Shou-Nien Hou, 7F21
U.S. Nuclear Regulatory Commission

Enclosed are the responses to Piping Design Audit open items A-10, A-17 and A-28. If you have any questions please call me (488-925-4824) or Maryann Herzog (408-925-1921).

GE-NE
ABWR PROGRAM
MECHANICAL SYSTEM DESIGN
FILE MH-A10

SUBJECT: AUDIT ITEM A-17
THERMAL STRESSES DUE TO FEEDWATER NOZZLE STRATIFICATION
STRIPPING EFFECT

FIGURE 1. DUTY CYCLE

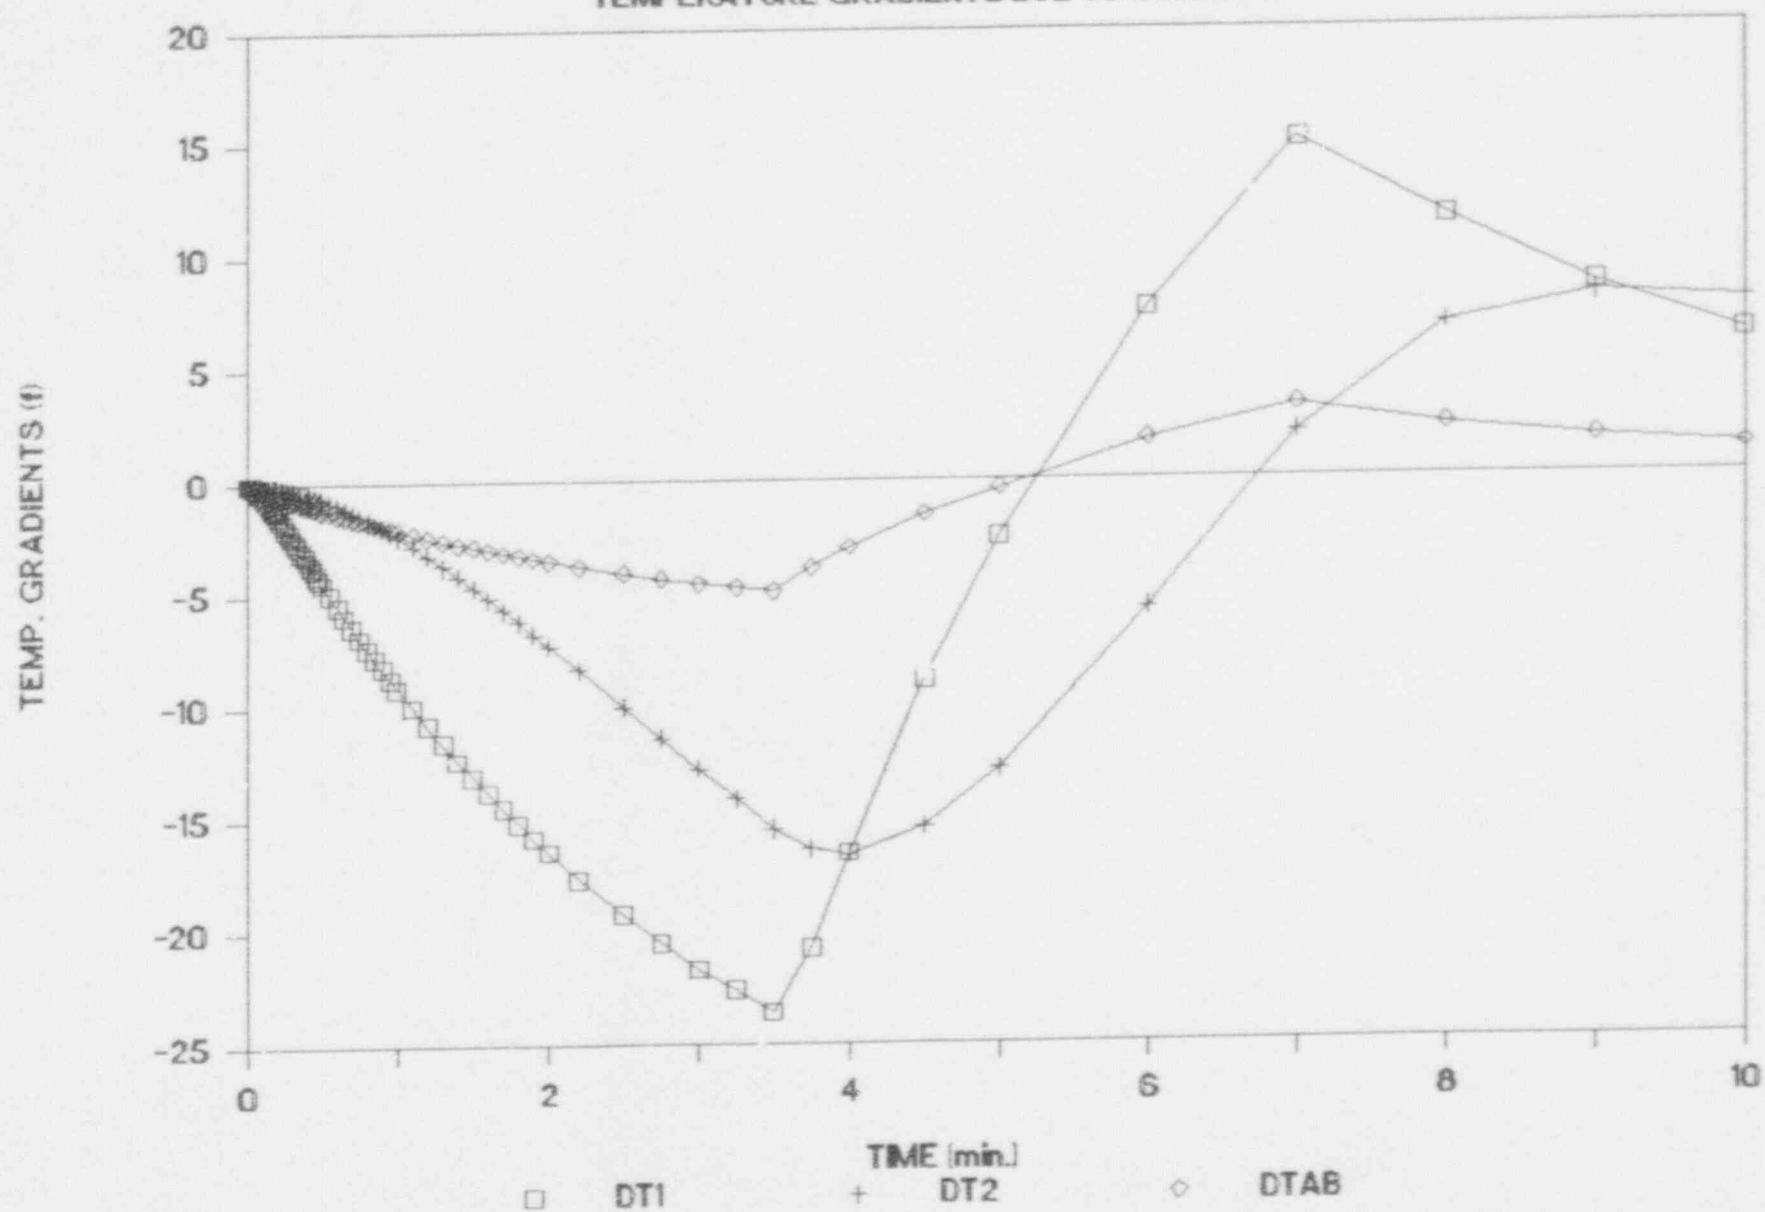
The temperature gradient stresses due to stripping has been included in the current thermal duty cycle charts. The stripping occurs during hot standby. Attached Figure 1 shows the hot standby event. This figure shows the requirement to calculate the temperature gradients due to step change from 132 to 99 degree C and back from 99 to 132 degree C. Using 2% rated flow during hot standby the calculated temperature gradients ranges from the cycle are as follows:

Although the temperature transients step change of 59.4 degrees is not exact the same as the data measured from the plant, but the net results are about the same. Based on Leibstadt plant measured data the maximum temperature change on top of the nozzle is from 375 to 135 degree F in 3.5 minutes. The temperature change at bottom of the nozzle is less than 1/3 of the top of the nozzle.

The worst assumption is to assume 375 to 135 and back to 375 cycling. The temperature gradients time history due to the stripping effect has been calculated. The results are plotted in Figure 2. The temperature gradient ranges are as follows:

This shows that the temperature gradients calculated from both cases are about the same. The allowable fatigue cycles for the alternating stress from either case are more than 1000,000 cycles.

This concluded that the current feedwater duty cycle requirement is adequate for the stripping effect.
